PROTERRA

TECHNICAL SERVICE BULLETIN

ISSUE DATE:	6-10-2021
SERVICE BULLETIN SUBJECT:	800 Volt Catalyst 35 Horn Relay Retrofit
VINs or MODELS AFFECTED:	Service Specified Buses
COMPLETE BY:	Next Service Opportunity
SERVICE BULLETIN #:	SC-21-83
LABOR OPERATION CODE:	DE42Z

800 VOLT CATALYST 35 HORN RELAY RETROFIT

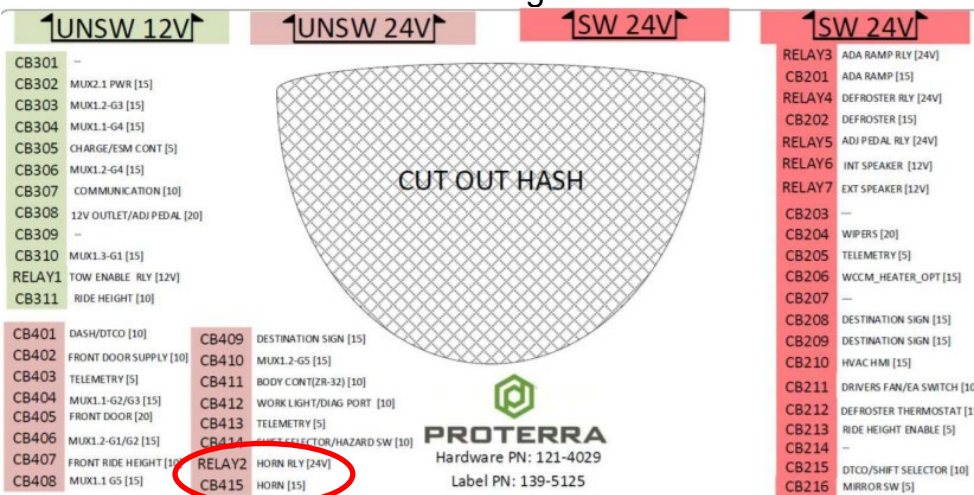
This procedure updates the horn relay and circuit breaker to more robust versions.

- 058300 RETROFIT KIT, 35' RR HORN RELAY/FUSE REPLACEMENT (Consisting of)
 - 139-5125 LABEL, ELECTRICAL CENTER, ECAB 1 EA
 - 013529 CIRCUIT BREAKER, COOPER BUSSMAN, 15AMP 1 EA
 - 128-2640 RELAY, ULTRA MICRO, 24V DC COIL, 30A CONTACT 1 EA
